**7 A307 TARTAR HILL PEDESTRIAN CROSSING
PROPOSALS FOLLOWING THE REMOVAL OF
TARTAR HILL FOOTBRIDGE**

**OFFICER REPORT TO LOCAL COMMITTEE
(ELMBRIDGE)**

Version No. 1 Date: 18-09-12 No of annexes: 2

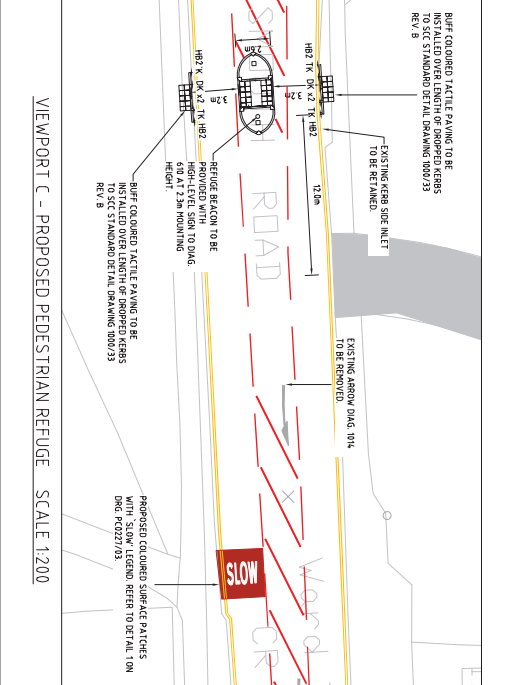
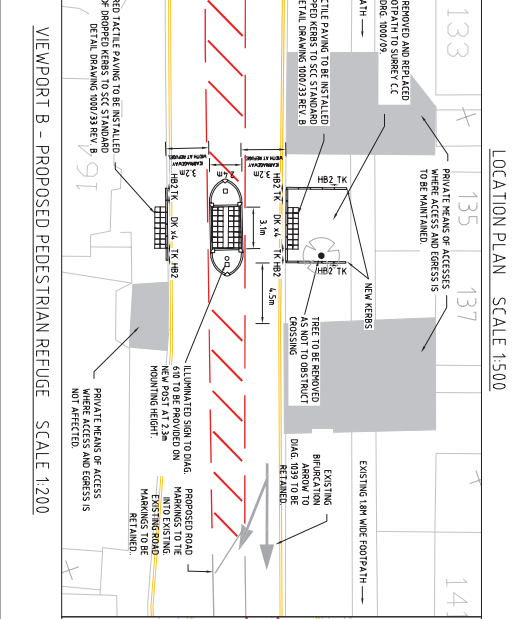
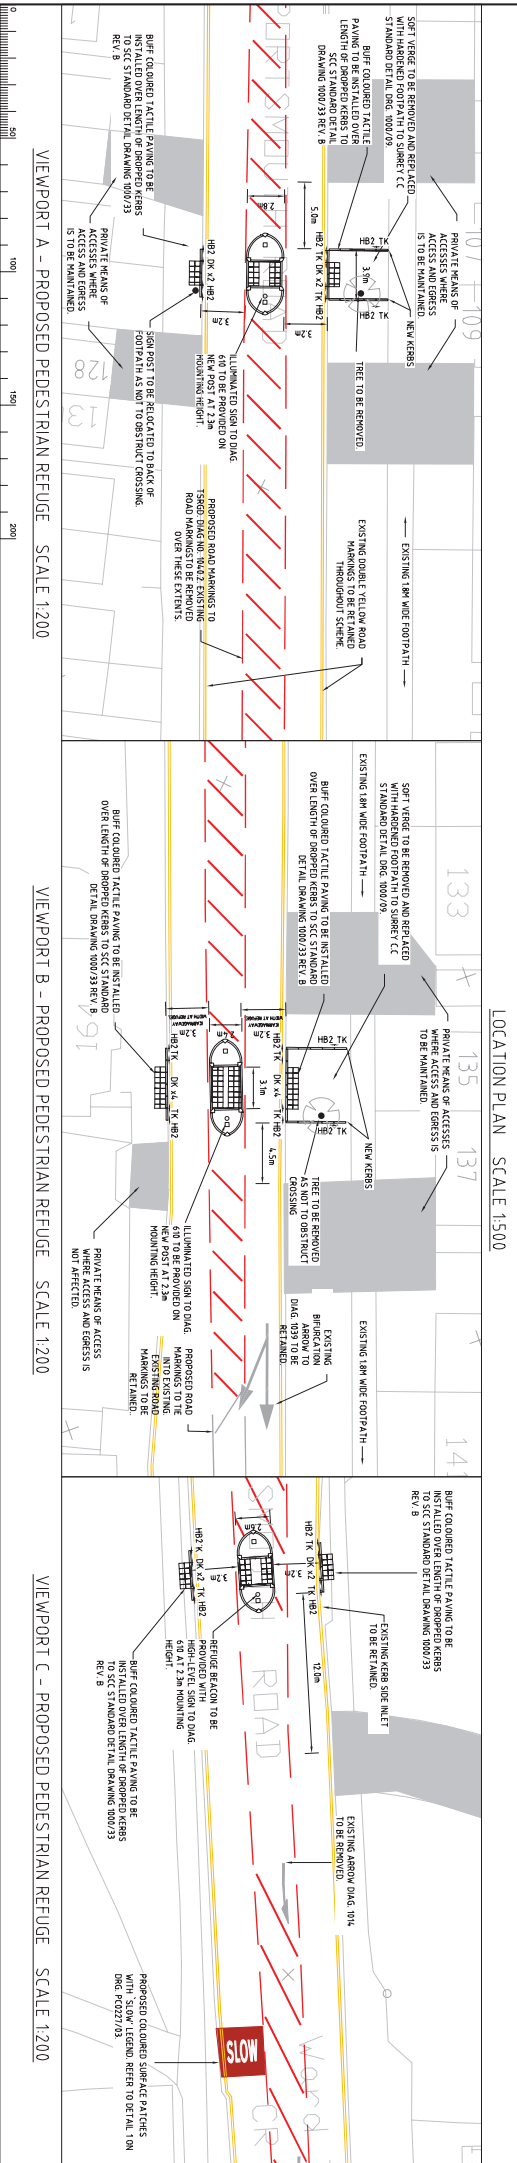
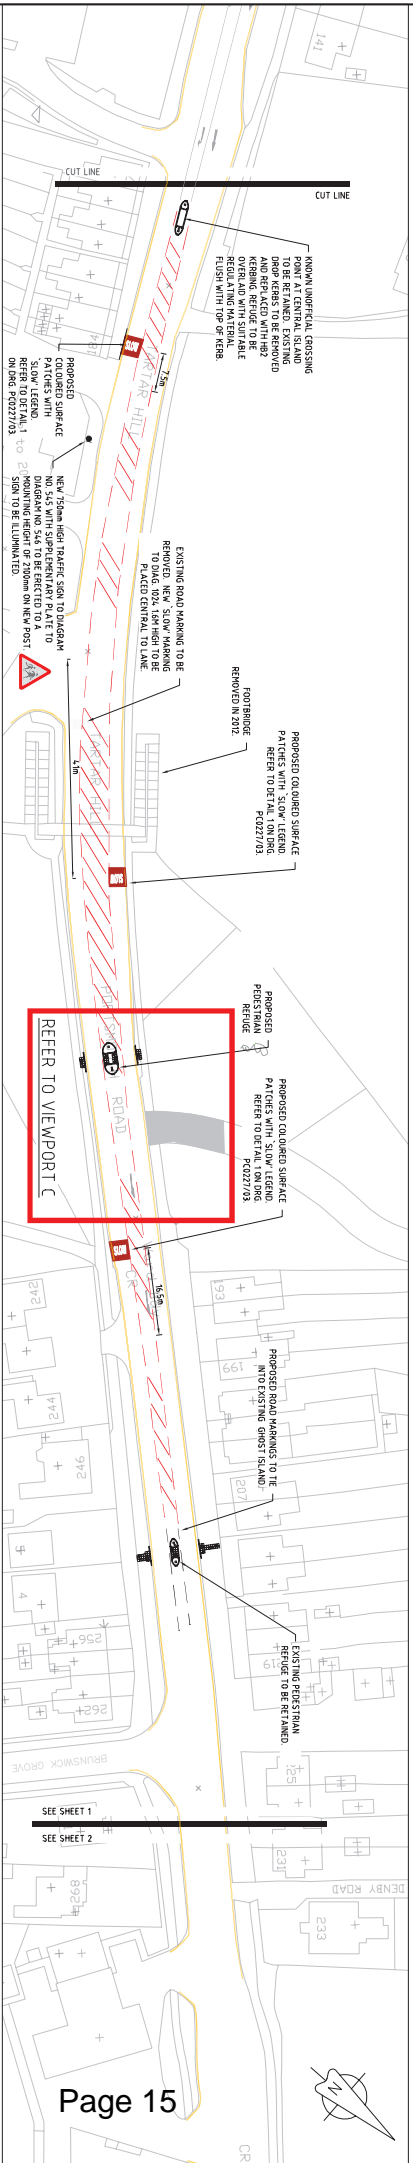
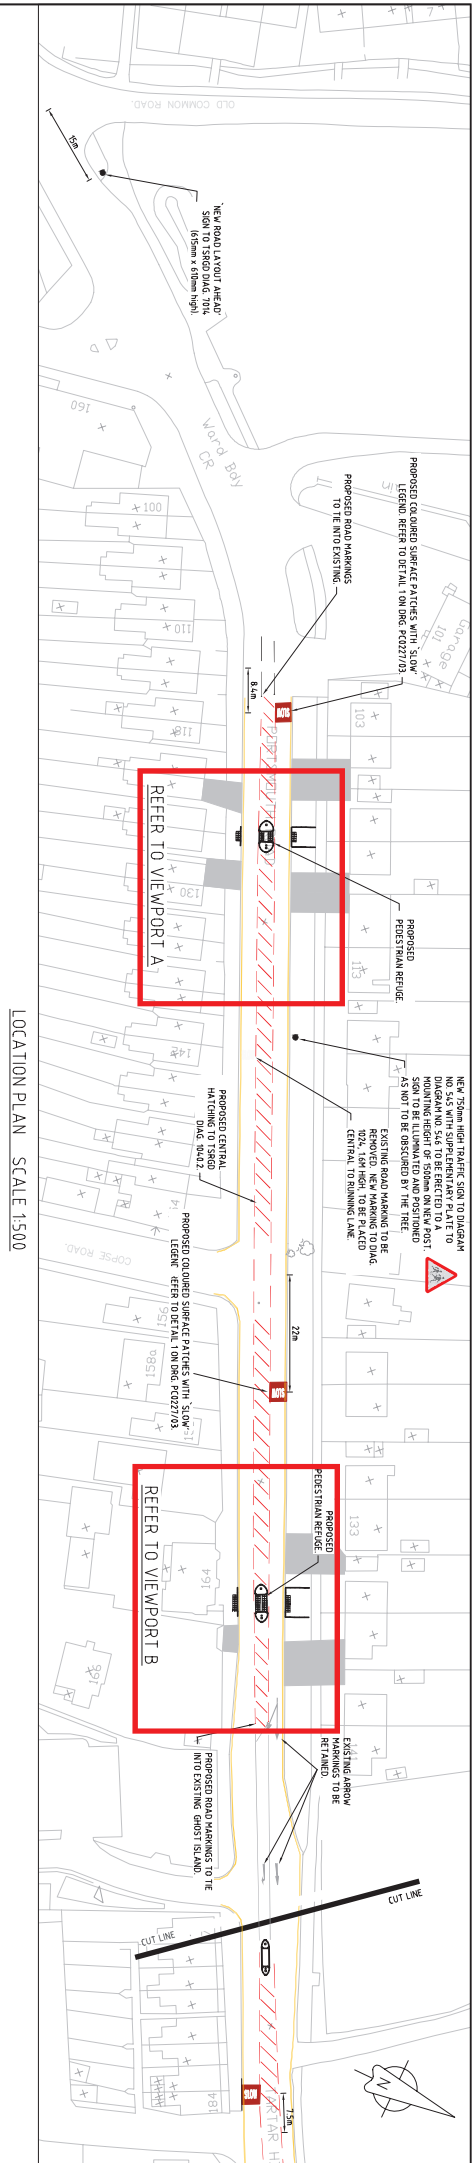
A2.1	Location: Viewport C Summary: unclear carriageway width. Dwg. PC0227/02 indicates a carriageway width of 9.7 metres (2 x 4.1 metre running lanes and 1.5 metre refuge). However, site measurements indicate a carriageway width of 9.1 metres. Also the drawing indicates that existing dropped kerbs are present at this location which observations show that there are full height kerbs. It is unclear if the site conditions will allow scheme proposals to be constructed as proposed.	Confirm running lane and refuge widths at the location of the proposed pedestrian refuge.	Carriageway width of 9.1m confirmed. Drawing revised accordingly showing reduced running lane widths of 3.2m with a refuge width of 2.6m, following instruction from Area Team Manager.
A2.2	Location Viewport C / Nos 177 – 191A Portsmouth Road Summary: restricted access to / from side road Large vehicles, including refuse vehicles are unable to turn right out of the side road onto A307 Portsmouth Road without over-running the proposed pedestrian refuge. This is due to the close proximity of the proposed pedestrian refuge to the side road access. Conflict with the refuge and / or pedestrians standing within the refuge may result.	Confirm turning circles of all expected vehicles can be achieved without conflict with the proposed refuge. Relocate the proposed refuge further to the south-west to allow all turning circles of expected vehicles to be performed. Ensure proposed pedestrian refuge / uncontrolled crossing area is clear of the existing side inlet gully which is located 6.3 metres to the west of the side road access to Nos. 177 – 191A Portsmouth Road.	Noted. Refuge relocated.

A2.3	Location Viewport B Summary: restricted access to / from private drive of Nos. 135 & 137 Portsmouth Road Vehicles are unable to turn right out of the private drive of No. 137 Portsmouth Road to travel south-west on the A307 Portsmouth Road without over-running the proposed pedestrian refuge. Also a left turn into the private drive may also result in over-running of the nearside kerb. Also the right turn into / left turn out of No. 135 Portsmouth Road is likely to result in vehicles conflicting with the kerbs of the pedestrian refuge. This is due to the close proximity of the proposed pedestrian refuge to the private drives. Conflict with the refuge and / or pedestrians standing within the refuge may result.	Reduce the length of the proposed pedestrian refuge. Ensure turning circles of all expected vehicles can be achieved in and out of the private drives.	Noted.
A2.4	Location Viewport A Summary: risk of conflict with refuge due to approach speeds and vehicle alignment. Observations suggest that north-eastbound vehicle speeds are at / above the existing speed limit in the vicinity of Anyards Road. Also north-eastbound drivers take the 'racing line' when proceeding along Portsmouth Road and over-run the existing central hatching on the approach to Viewport A. Drivers are likely to continue to take the 'racing line' following the introduction of the proposed pedestrian refuge and hence are at risk of conflict with the kerbs of the proposed pedestrian refuge. This places pedestrians within the refuge at risk of conflict.	Provide a traffic island to the north-east of Anyards Road to ensure A307 Portsmouth Road drivers travelling north-east do not over-run the central hatching on the bend (ensuring turning circles of vehicles exiting Anyards Road are not affected), or; Relocate proposed pedestrian refuge further to the south-west to improve drivers forward visibility of the feature. NB. This would be subject to appropriate location for the refuge to be positioned between existing private drives and associated turning circles and clearance of mature trees within the northern verge.	Noted, however it is considered that the pedestrian refuge is positioned beyond the bend, away from the over-run area. There is no obvious location for a traffic island or for the relocation of the pedestrian refuge due to their position in relation to nearby junctions and private means of accesses. It is expected that the traffic calming proposals will reduce traffic speeds and change driver behaviour. Refuge to remain as shown and situation to be monitored.

A3.3	Location Viewport B Summary: potential for restricted pedestrian visibility. It is unclear why a 6.0 metre length of pedestrian refuge / uncontrolled crossing is proposed. If the refuge is full of pedestrians, those standing at the south-western end of the refuge will be unable to view south-westbound traffic due to pedestrians standing at the north-eastern end of the refuge, unless they enter the running carriageway (i.e. their view of approaching traffic will be blocked by other pedestrians). Pedestrians leaning into / stepping into the running carriageway are at increased risk of conflict with passing vehicles. This situation is reversed when a large number of pedestrians wish to cross in the other direction.	Reduce the length of the proposed central pedestrian refuge.	Noted. Final dimensions of pedestrian refuge to be agreed. Existing pedestrian refuges have a total length of 5m. There are no regulations defining the length of a refuge, only a minimum width of 2m. Site observations identified pedestrians standing in the shadow of the island due to the high number of pedestrians, pushchairs, bikes and scooters crossing at one time. The dimensions of the refuge need to be suitable to cater for the pedestrian demand. During these busy periods, it is often only two or three adults supervising several children and it is only the adults that require the visibility to determine whether it is safe to cross. It is not considered that this situation is any different to crossing from a footpath as oppose to a central refuge. Length of pedestrian refuge (tactile area) reduced to 3m approx. to provide a pedestrian standing area of 3m x 2.4m.

A3.4	Location Viewport A and B Summary: risk of pedestrian conflict. Pedestrians crossing from the proposed pedestrian refuges to the northern footway are at risk of conflict with the existing mature trees located within the existing verge. This is of particular concern to the visually impaired. Also pedestrians wishing to cross to the proposed pedestrian refuges from the northern footway, may be masked from approaching drivers by the foliage of the trees, which increases the potential for conflict when pedestrians attempt to cross the carriageway. This is of particular concern during dark conditions.	Confirm proposals for trees. Remove trees to maximise available footway width and visibility for and of pedestrians wishing to use proposed pedestrian refuges.	Reluctant to remove trees unless directly hindering footway access. Further investigation required to determine scope for realigning crossing to avoid trees.

A3.5	Location Viewport A Summary: Pedestrians at risk of conflict with post. Pedestrians crossing from the proposed pedestrian refuge to the southern footway (outside No. 134 Portsmouth Road) are at risk of conflict with the item of street furniture mounted in the footway (post with parking plate). This is of particular concern to the visually impaired.	Remove / relocate post clear of the uncontrolled crossing location.	Post to be relocated.
A3.6	Summary: drivers at risk of conflict with refuges. Due to the downhill gradient of the A307 Portsmouth Road, south-westbound drivers may not fully appreciate the location of the proposed pedestrian refuges. Conflict with the refuges may result, especially during dark conditions.	Provide high-level signs to Diag. 610 on each refuge beacon.	Agreed. Illuminated high level signs to Diag. 610 to be provided on new posts for pedestrian refuges in Viewport A and B. It is not considered that a refuge beacon is required at these locations to enhance driver awareness due to good visibility and flat gradient. Additionally concerns will be raised due to their proximity to residential properties. High level sign to be positioned on refuge beacon at Viewport C, as it is located on a hill and does not directly impose on nearby dwellings. Drawing to be revised accordingly.
